PROJECT **WATERVUE**
643-651 HUNTER STREET NEWCASTLE NSW 2300

DRAWING No. DA011
DRAWING TITLE PLANNING - GFA
SCALE 1 : 250 @ A1
DATE 2023

DEVELOPMENT APPLICATION SHEET LIST		
DRAWING NO.	TITLE	REVISION
DA000	PLAN - LOCATION & DRAWING SCHEDULE	H
DA002	SITE ANALYSIS	B
DA003	PREDICT LOCATION PLAN	C
DA005	SITE PLAN	C
DA006	SHADOW DIAGRAMS	B
DA007	SHADOW DIAGRAMS	B
DA008	SHADOW DIAGRAMS	A
DA009	SOLAR ACCESS DIAGRAM	B
DA010	VENTILATION DIAGRAMS	B
DA011	PLANNING - GFA	G
DA012	UNIT AREA FOR CARPARKING GEN.	D
DA101	GROUND FLOOR	I
DA102	PARKING LEVEL 1	G
DA103	PARKING LEVEL 2	F
DA104	PARKING LEVEL 3	F
DA105	PLAN - PODIUM	H
DA106	PLAN - TYPICAL LOWER	G
DA107	PLAN - TYPICAL UPPER	F
DA111	PLAN - PENTHOUSES	C
DA112	ROOF	B
DA200	STREETSCAPE ELEVATIONS	B
DA201	ELEVATIONS - NORTH AND EAST	F
DA202	ELEVATIONS - SOUTH AND WEST	C
DA301	SECTIONS	C
DA321	RAMP SECTION CARPARK	C
DA401	PERSPECTIVE	B
DA402	PERSPECTIVE	B
DA403	PERSPECTIVE	B
DA409	MATERIALS + FINISHES	B
DA801	PODIUM LEVEL PRIVACY SCREENS	A
DA802	SIGNAGE DESIGN INTENT	A

DRAWING No. **DA301**
DRAWING TITLE **SECTIONS**
SCALE **1 : 200 @ A1**
DATE **2022**

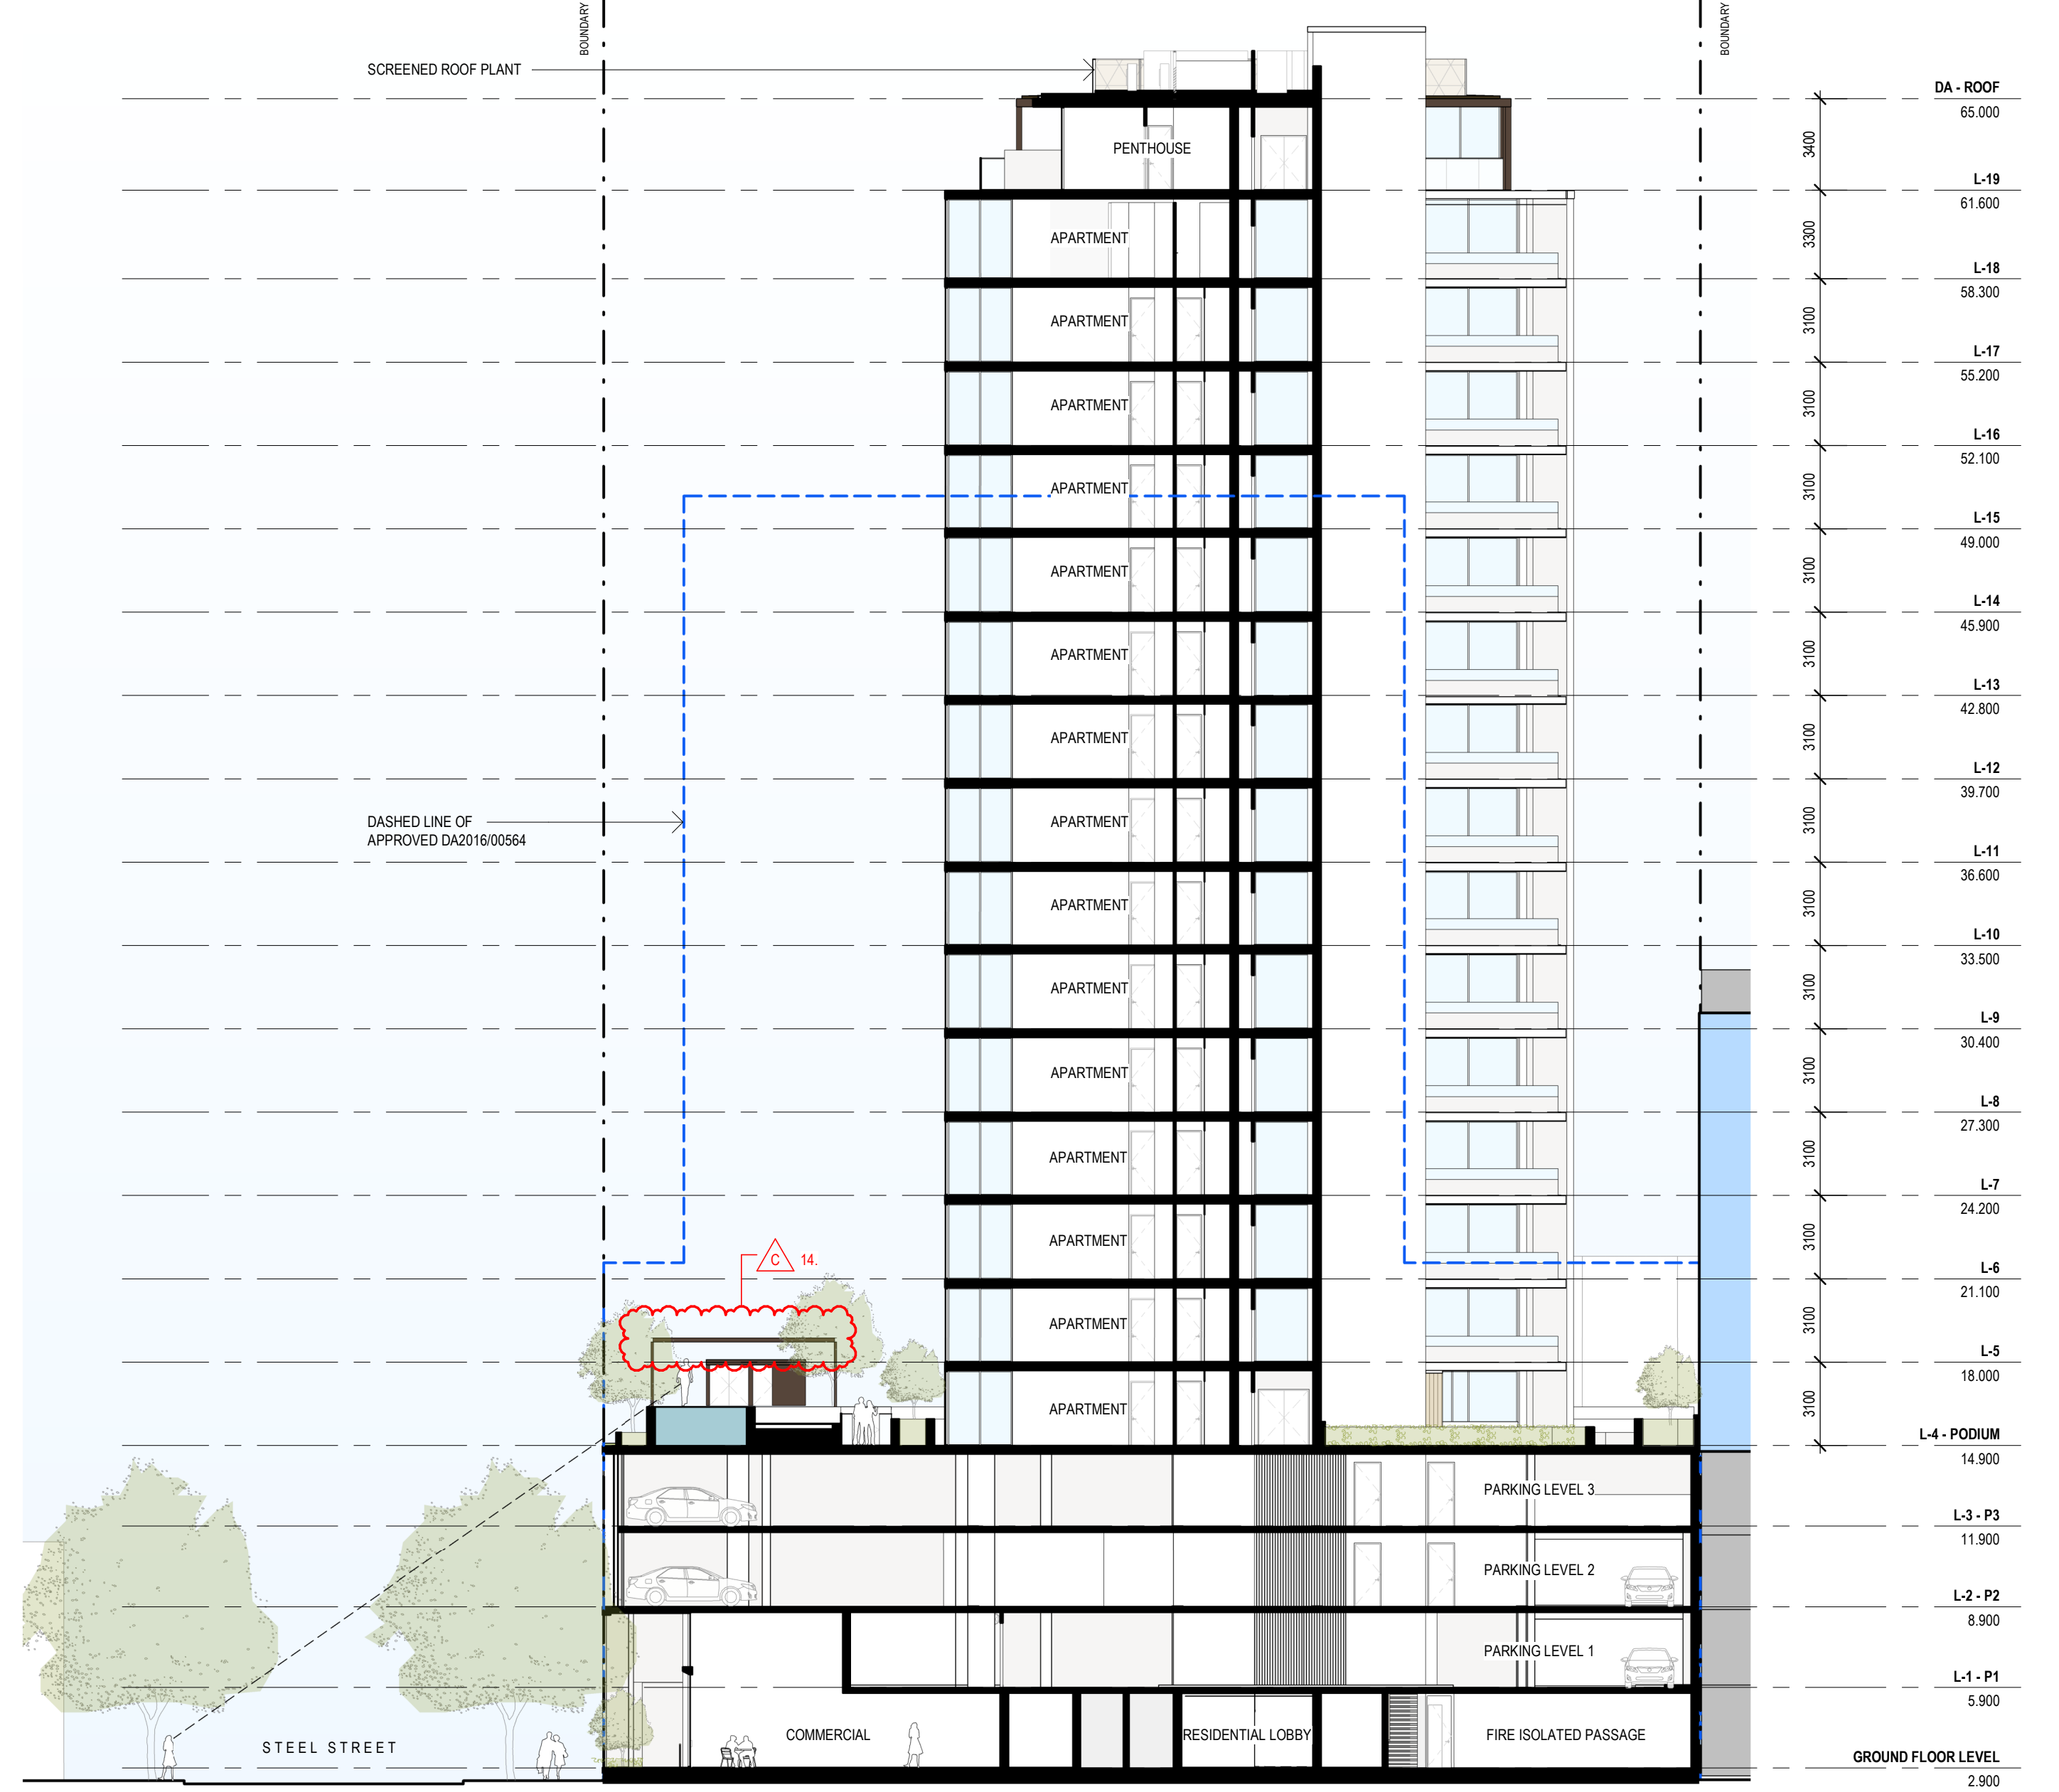
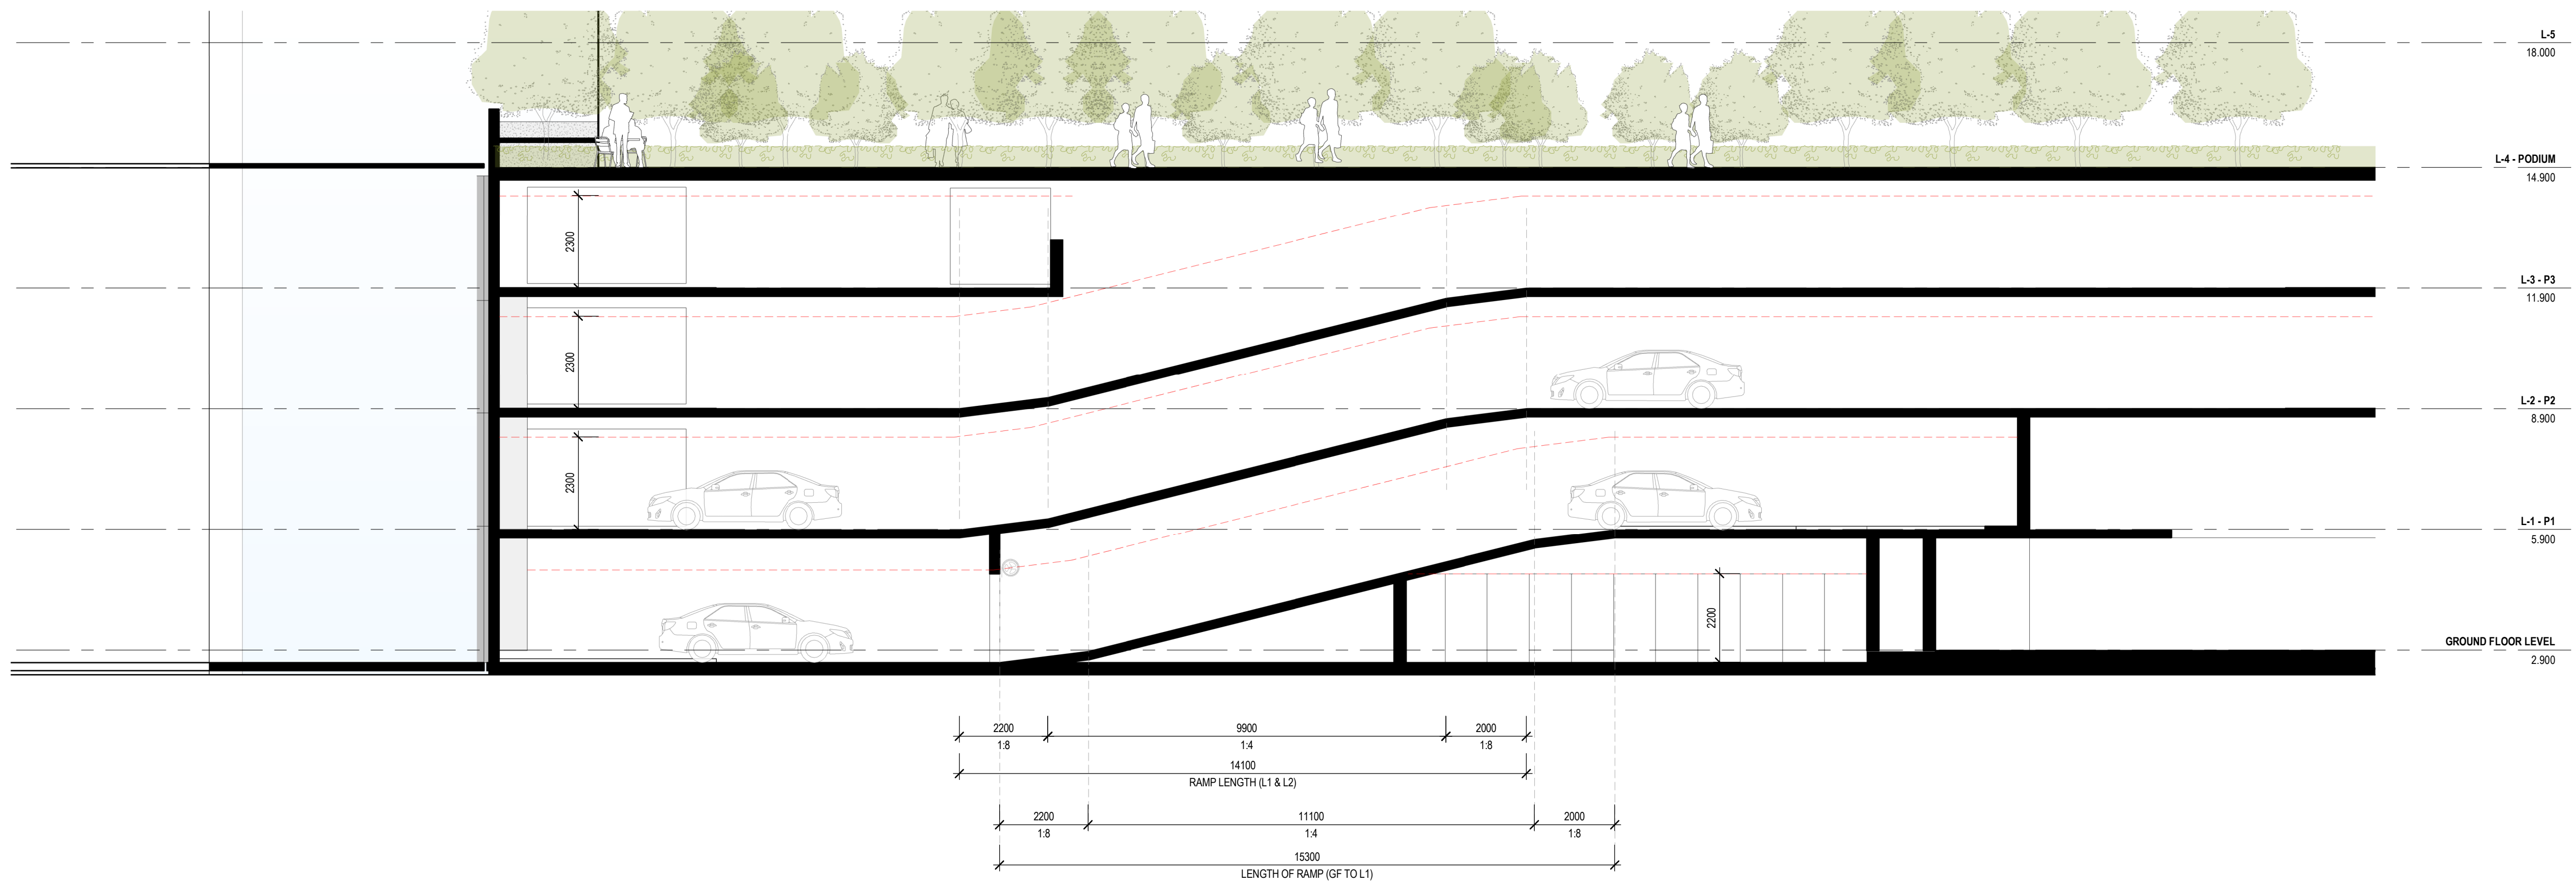
DA RFIS

1. GROUND FLOOR CARPARKING LEVEL LOWERED BY 300MM
2. DRIVEWAY GRADES UPDATED TO SUIT UPDATED PARKING LEVEL
3. DOOR TO FIRE EGRESS CORRIDOR RELOCATED
4. STEP ADDED TO FIRE EGRESS PATH TO SUIT UPDATED PARKING LEVEL
5. STEPS AND PLATFORM ADDED TO MSB ROOM TO SUIT UPDATED PARKING LEVEL
6. MAIL ROOM ADDED TO RESIDENTIAL LOBBY
7. MAILBOXES RELOCATED INTO THE RESIDENTIAL LOBBY
8. MOTORCYCLE SPACE DISTRIBUTION ACROSS L1, L2 AND L3 UPDATED (TOTAL REMAINS THE SAME)
9. SECURE ENTRY ADDED AT BASE OF RESIDENTIAL CARPARK RAMP
10. GF TO L1 RAMP LENGTH UPDATED TO SUIT UPDATED GROUND FLOOR PARKING LEVEL
11. GARAGE ADDED TO L1 AND L2
12. STORAGE CAGE ARRANGEMENT UPDATED
13. LANDSCAPE COURTYARD ACCESS DOOR ADDED TO PODIUM LEVEL
14. POOL PERGOLA SHOWN IN ELEVATION

DRAWING No. **DA321**
DRAWING TITLE **RAMP SECTION CARPARK**
SCALE **1:100 @ A1**
DATE **2022**

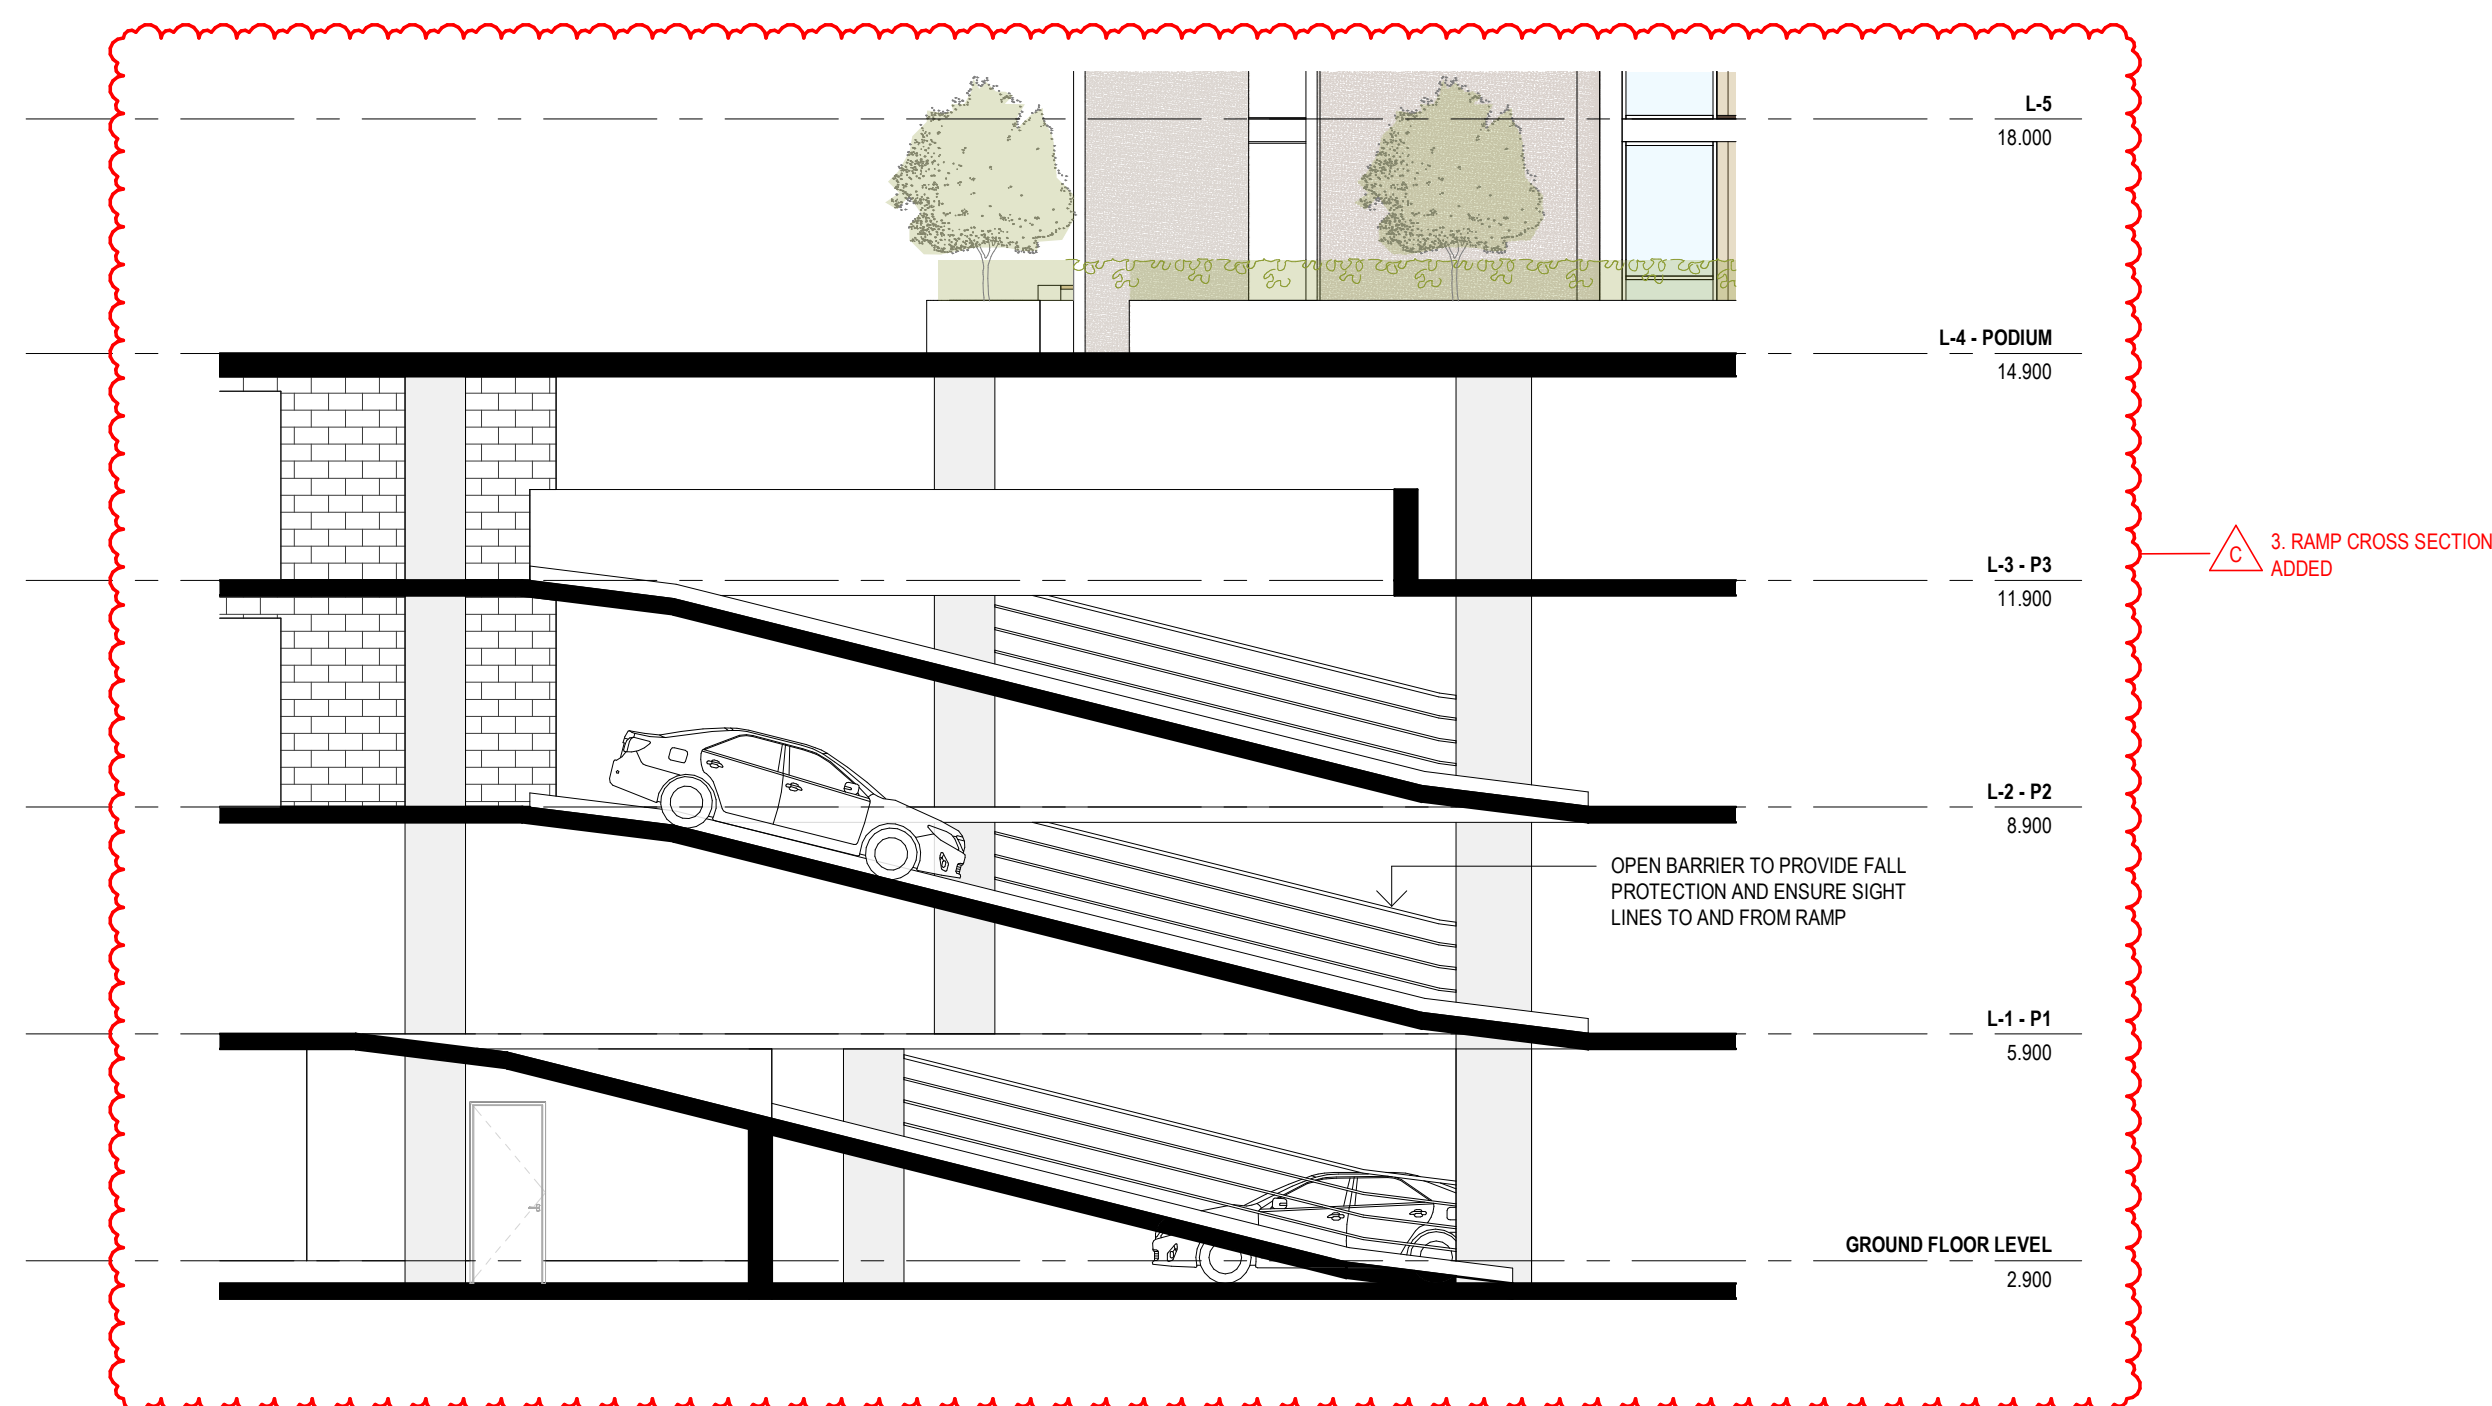
DA RFI - 17.02.2023

- NOTCHES IN AWNING ADDED
- FUTURE STREET TREE CLEARANCE INDICATED
- ADDITIONAL RAMP SECTION PROVIDED
- RAMP EDGE CONDITION CLARIFIED
- COMMERCIAL TENANCY STORAGE, WIC'S, COMMS ROOM, MAIL ROOM
RECONFIGURED TO CREATE FLOOD EVACUATION PATH
- STAIRS REMOVED
- STAIRS REMOVED RAMP ADDED
